RE: Addendum No. 1 to the Bidding Documents for:
RIVERTON HVAC & POOL REPAIRS

RE: Addendum No. 2 to the Bidding Documents for:
RIVERTON HVAC & POOL REPAIRS

RIVERTON HVAC AND POOL REPAIRS

RIVERTON ELEMENTARY SCHOOL

ARCHITECTURAL DEMOLITION PLAN
RIVERTON HVAC AND POOL REPAIRS
RIVERTON ELEMENTARY SCHOOL
PORTLAND, MAINE

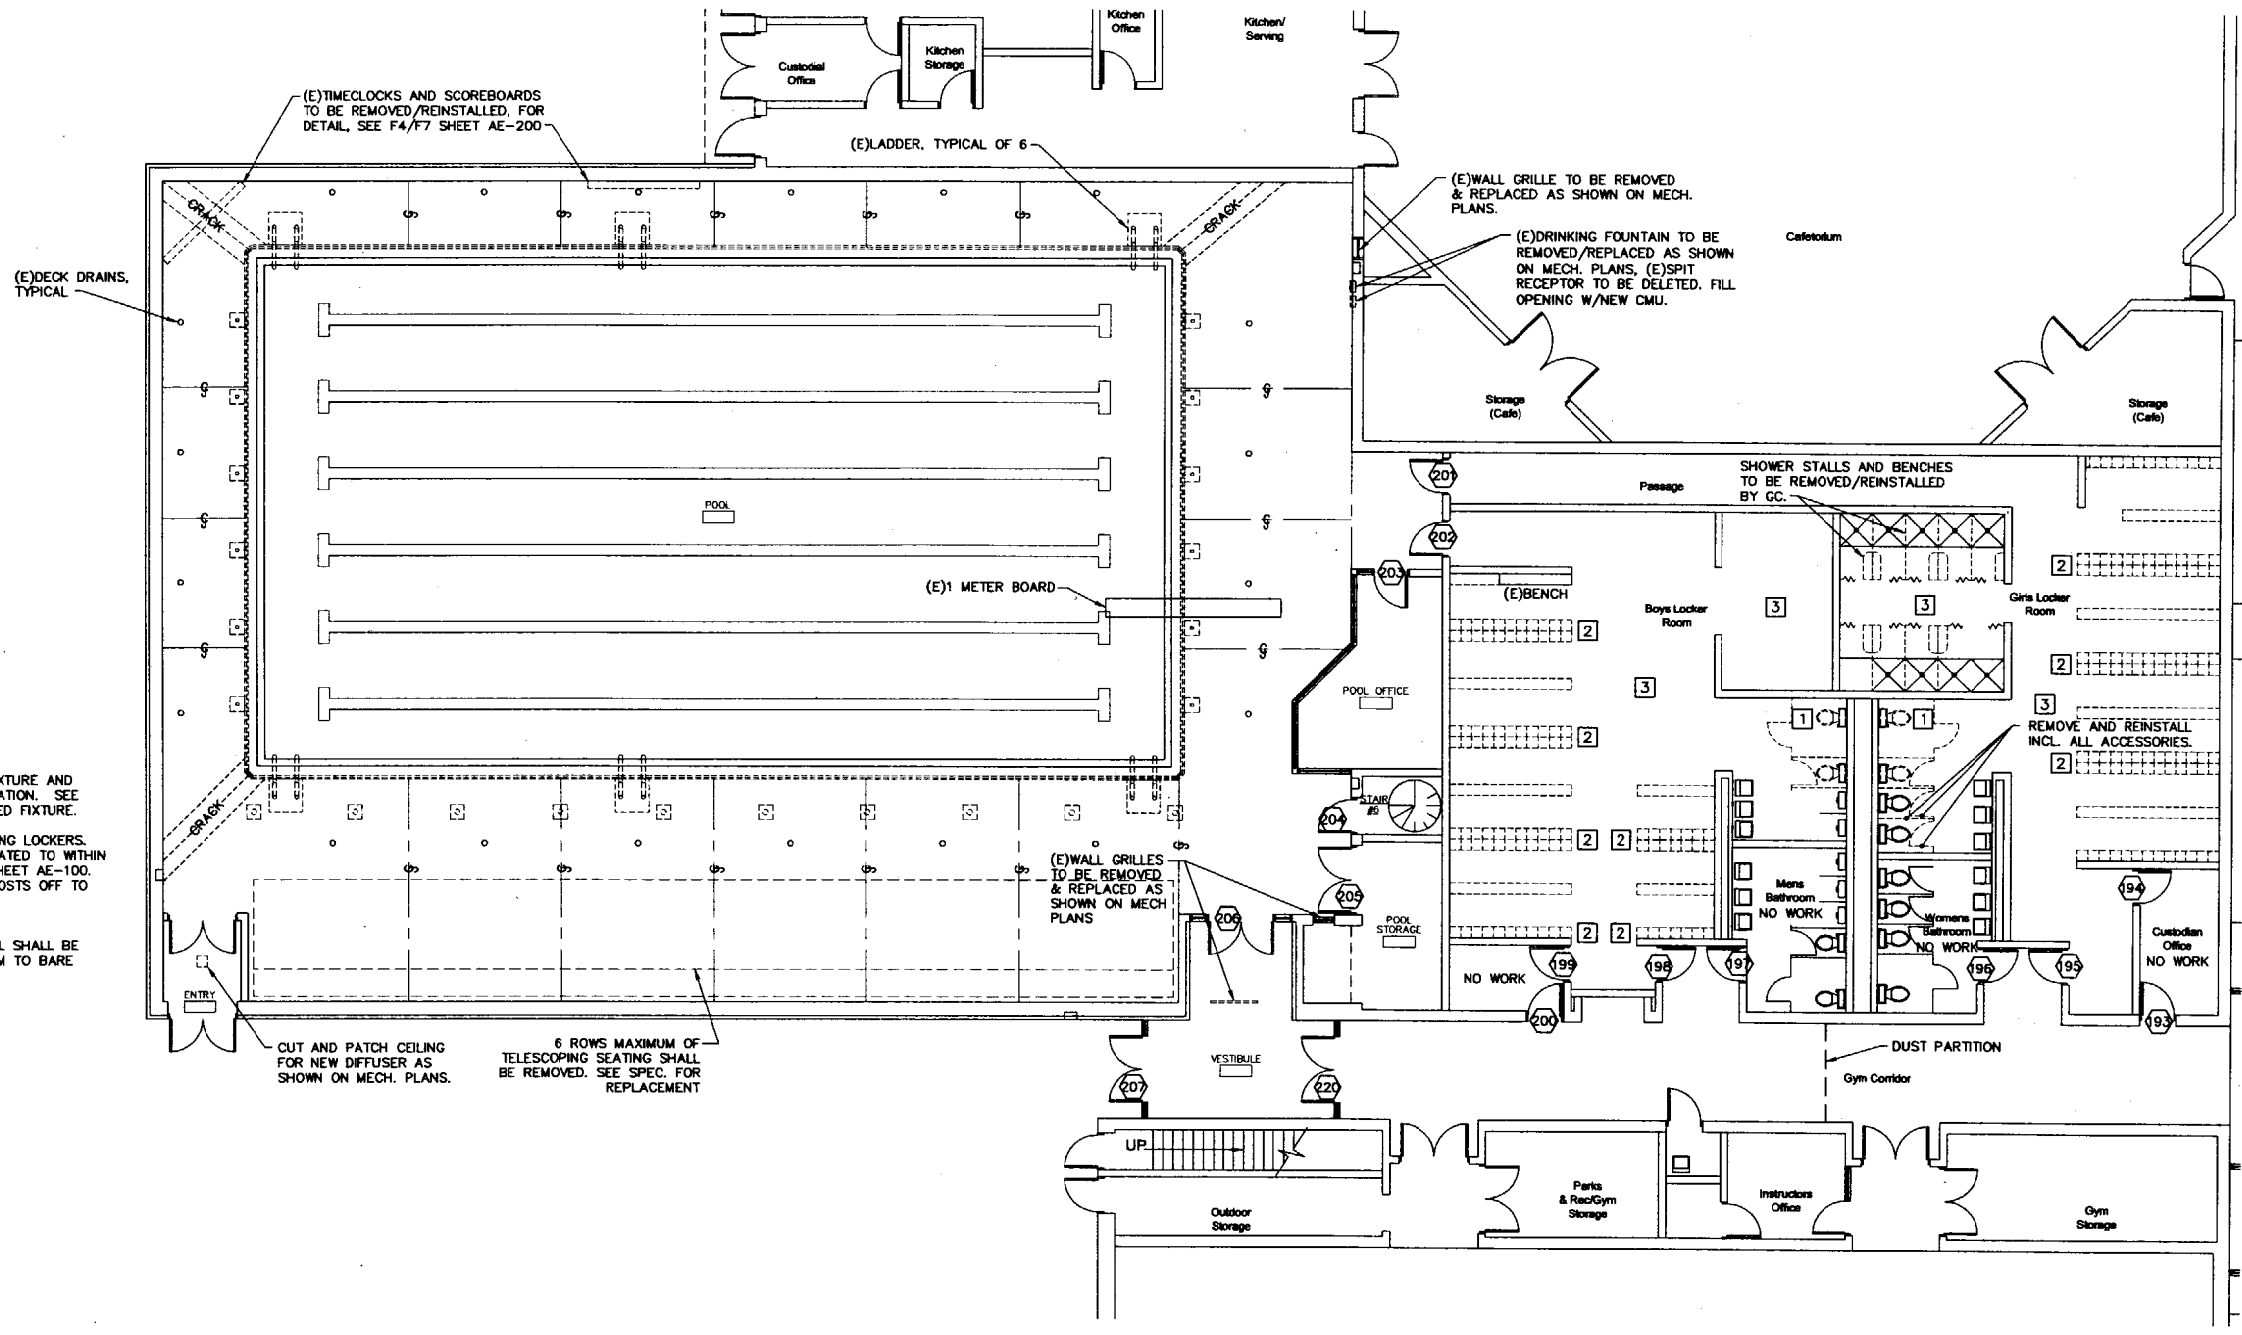
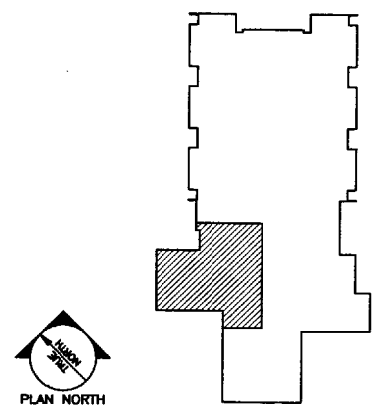
Delete KEY NOTE 3 in its entirety.

Add KEY NOTE 3: "ENTIRE EPOXY FLOOR FINISH AND 4" BASE UP WALL SHALL BE REMOVED TO BARE CONCRETE. OWNER WILL INSTALL NEW TILE FLOORING. REMOVE EXISTING SURFACES TO THE SATISFACTION OF THE OWNER, AND CONSISTENT WITH THE REQUIREMENTS OF THE TCA HANDBOOK SPECIFIED IN SECTION 09300. RECOMMENDED EQUIPMENT FOR REMOVAL INCLUDES POWERED ROTARY FLOOR PLANERS AND MULTI-HEAD SCABLERS OR DECK SCALERS EQUAL TO UNITS MANUFACTURED BY TRELAWNY."

Delete: KEY NOTE 2 in its entirety.

Add: KEY NOTE 2: “THE GENERAL CONTRACTOR (GC) SHALL REMOVE ALL LOCKERS. THE CITY OF PORTLAND PARKS DEPARTMENT STAFF WILL SALVAGE THE BEST 25-30 OF THE LOT AND THE PORTLAND PUBLIC SCHOOLS WILL REMOVE 10-15 DOOR HANDLE MECHANISMS PRIOR TO GC DISPOSAL. REMOVE 4” CONCRETE LOCKER BASES WHERE INDICATED TO WITHIN ½” MAXIMUM BELOW SURFACE, SEE DETAIL A3, SHEET AE-100. REMOVE BENCHES WHERE INDICATED, CUT BENCH POSTS OFF TO BELOW FINISHED SLAB SURFACE.”

Add: the following Note to Key Note 3 as revised in Addendum 1; “AT EACH LOCKER ROOM INTERIOR, CONCRETE SLAB SHALL BE PLANED OR CHIPPED TO A DEPTH OF ½” IN A TAPERED RAMP-LIKE AREA OF 4.5’ x 8’ AT EACH DOOR OPENING (4 LOCATIONS TOTAL).

ARCHITECTURAL PLAN
RIVERTON HVAC AND POOL REPAIRS
RIVERTON ELEMENTARY SCHOOL
PORTLAND, MAINE

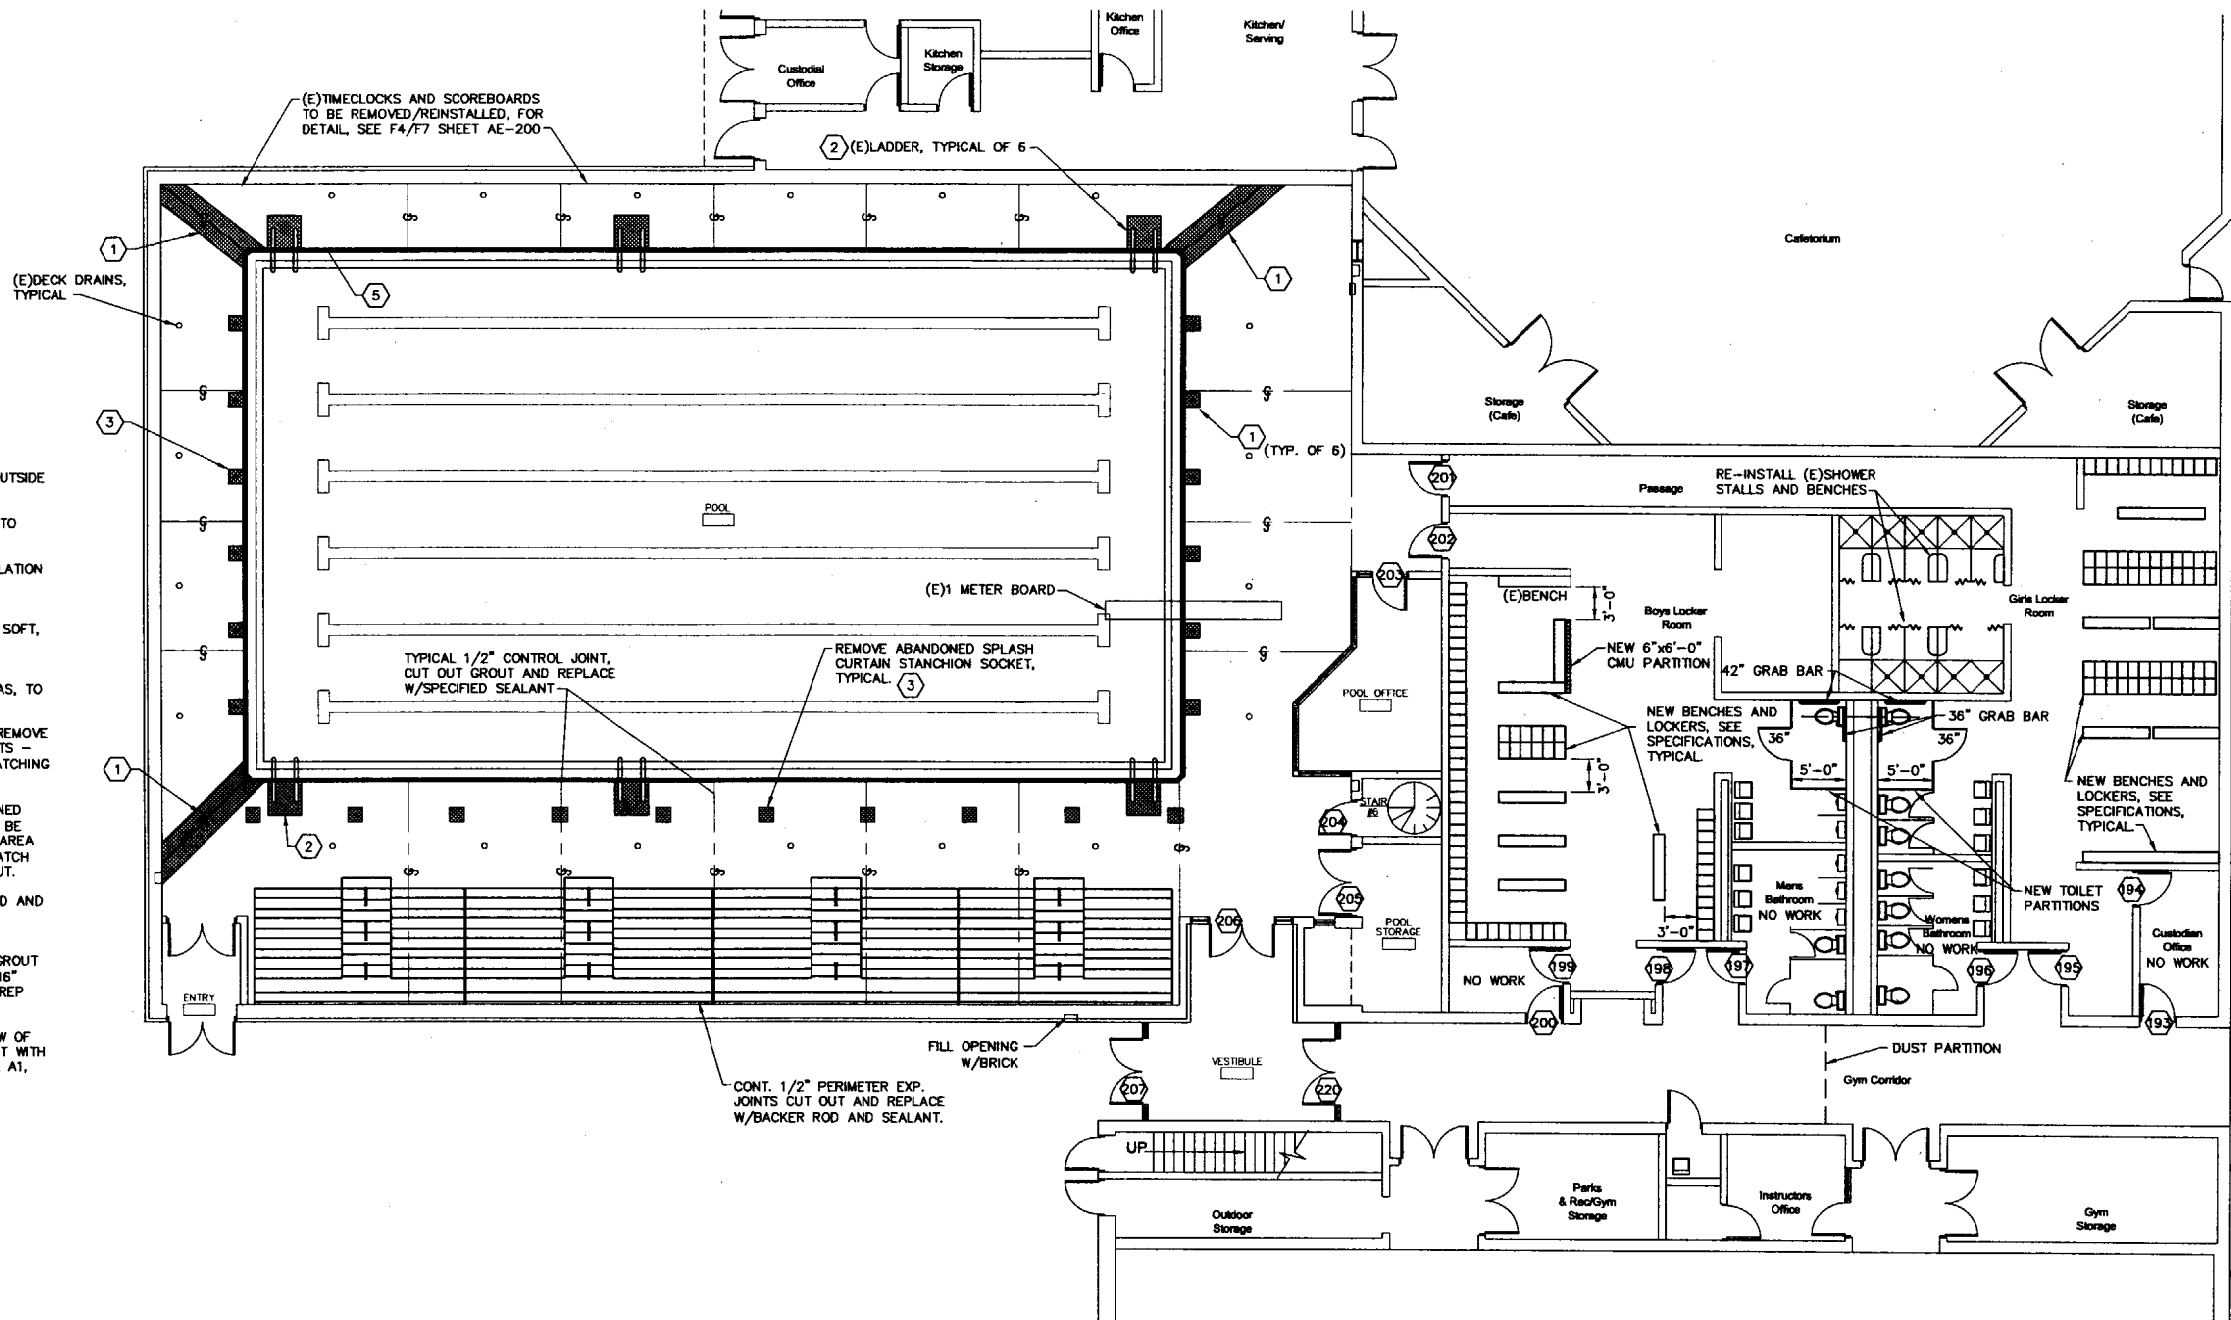
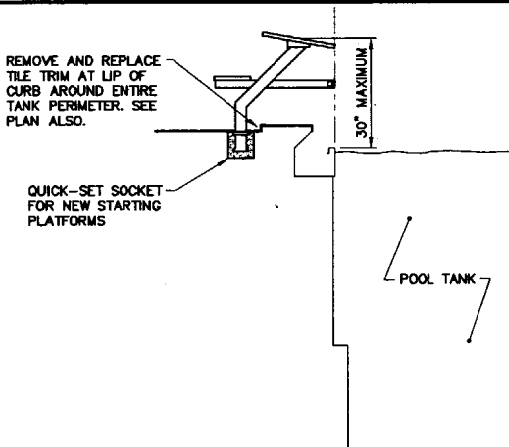
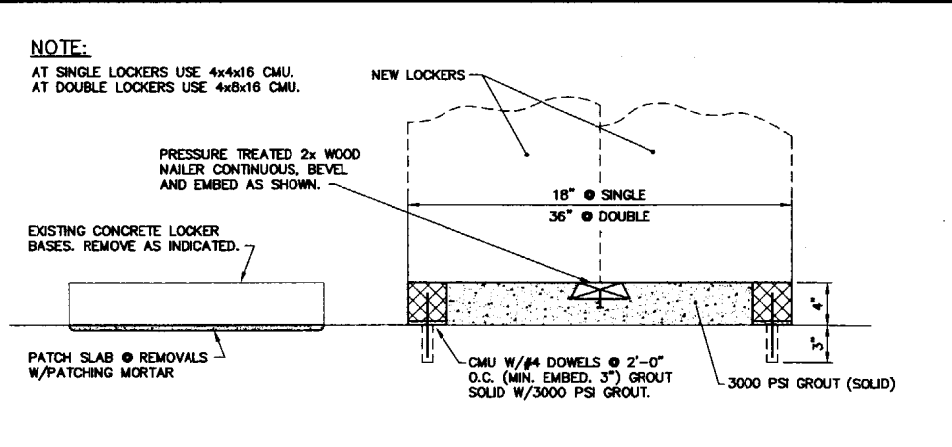
Add note: "FURNISH AND INSTALL NEW BLEACHERS AS SPECIFIED. PROVIDE SIDE CLOSURE PANELS OF ALUMINUM PLATE ON ENDS WHERE SEATING ROW EXTENDS BEYOND ADJACENT WALL. " [Bleachers are shown at South side of pool space.]

Delete: Keynote 1 at East end of Pool

Add: Keynote 4 at East end of Pool to read “4- (Typical of 6)”.

Delete: the last two sentences in Key Note 4.

Add: the following to Key Note 4: “REMOVE TILE IN AREA OF 12 TO 16 INCHES SQUARE, CENTERED ON NEW STARTING PLATFORM PEDESTAL LOCATIONS. PREPARE SLAB IN AREAS OF REMOVALS, TO RECEIVE NEW CERAMIC TILE AFTER INSTALLATION OF NEW PLATFORM SOCKETS. INSTALL TILE AND GROUT TO MATCH EXISTING SIZE, COLOR, AND PATTERN.”

INTERIOR ELEVATIONS AND DETAILS
RIVERTON HVAC AND POOL REPAIRS
RIVERTON ELEMENTARY SCHOOL
PORTLAND, MAINE

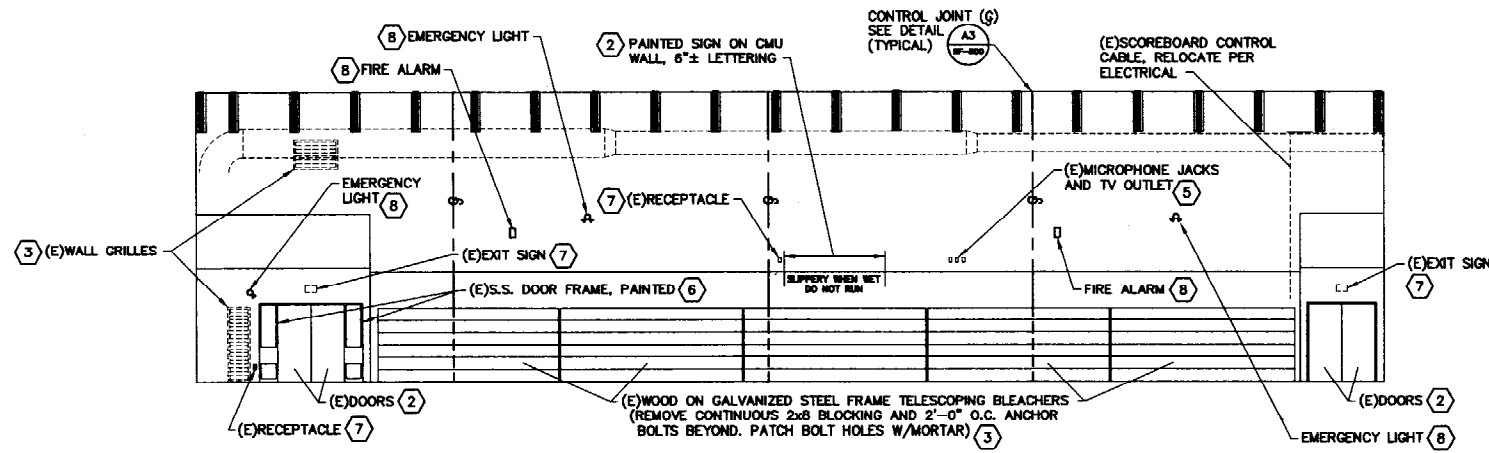
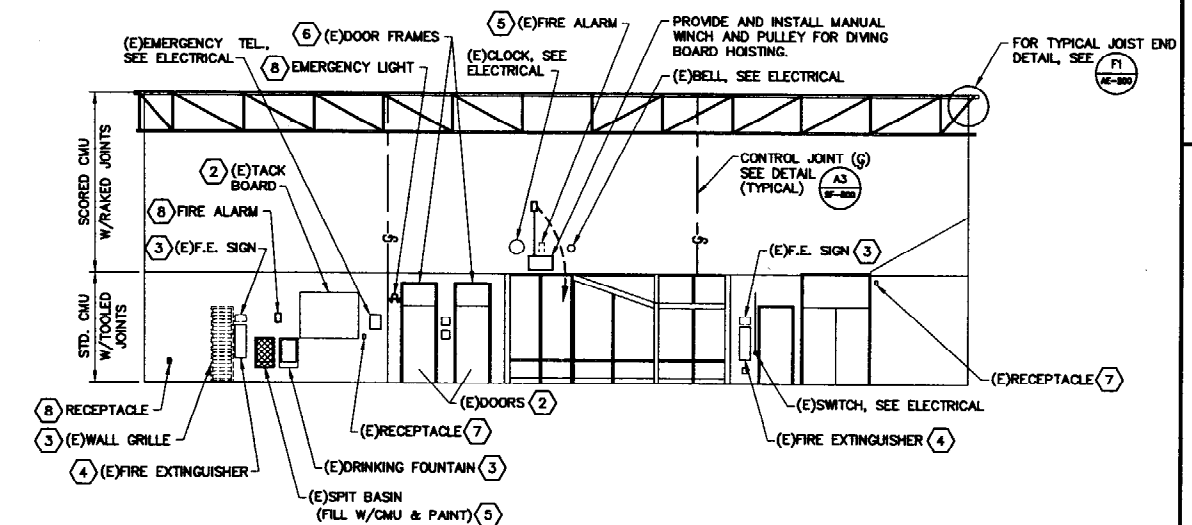
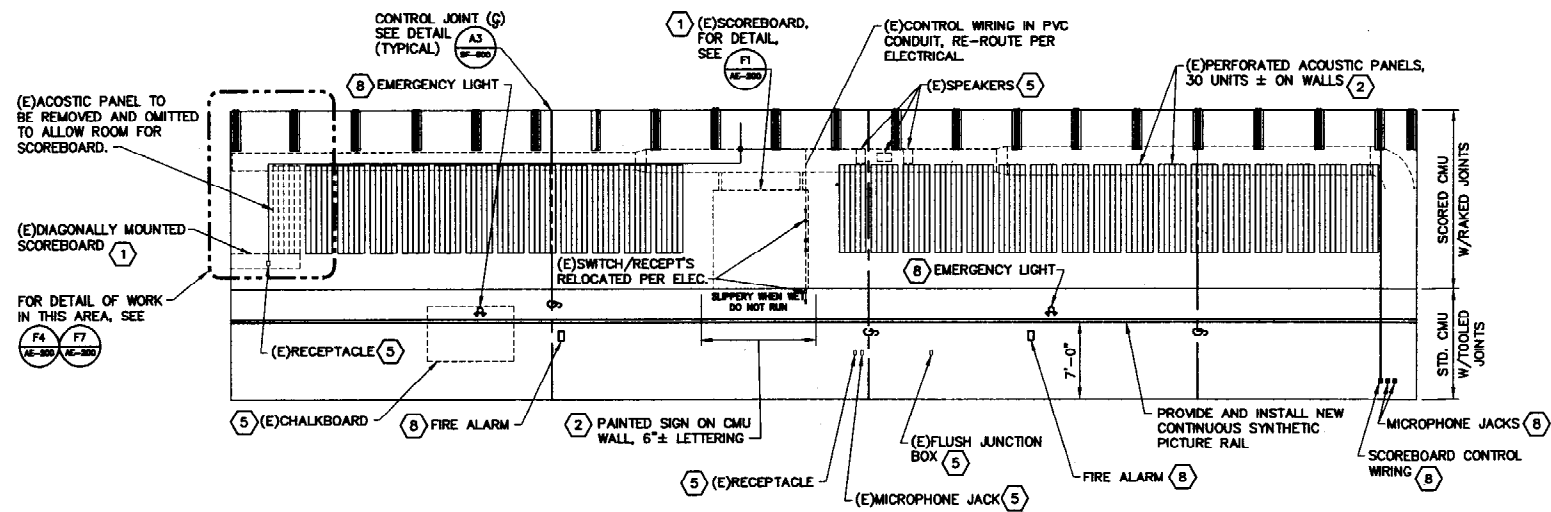
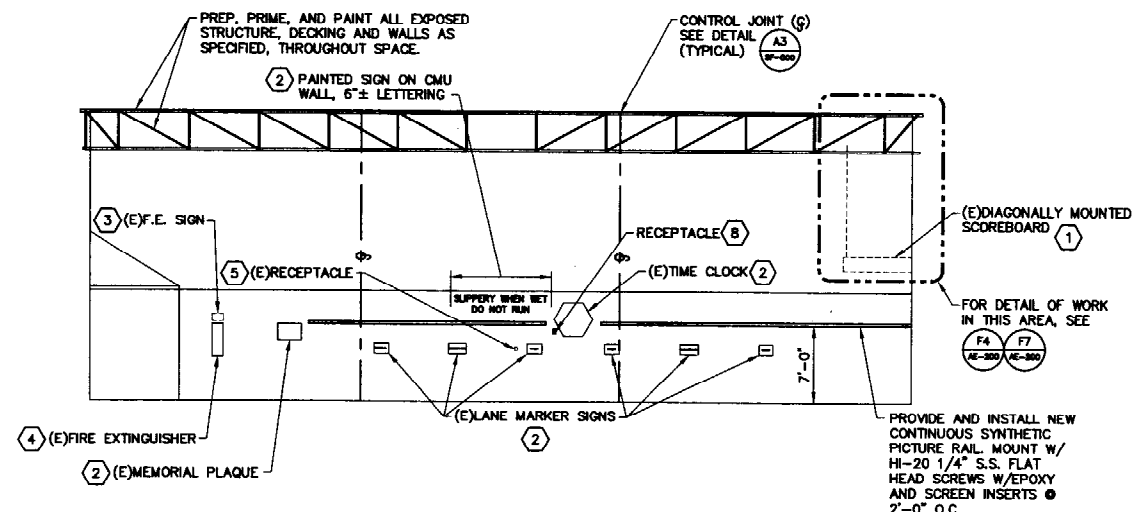
Add note: "INSTALL A WARNING SIGN AT EACH END OF PICTURE RAIL. RAILING WEIGHT LIMIT: DO NOT HANG ANY ITEMS HEAVIER THAN 100 LBS. SIGNS SHALL BE SETON CUSTOM WORDED WORKPLACE SIGNS, OR EQUAL; 60-MIL PLASTIC, 10" X 7" DIMENSIONS. COLORS SHALL BE AS SELECTED BY ARCHITECT"
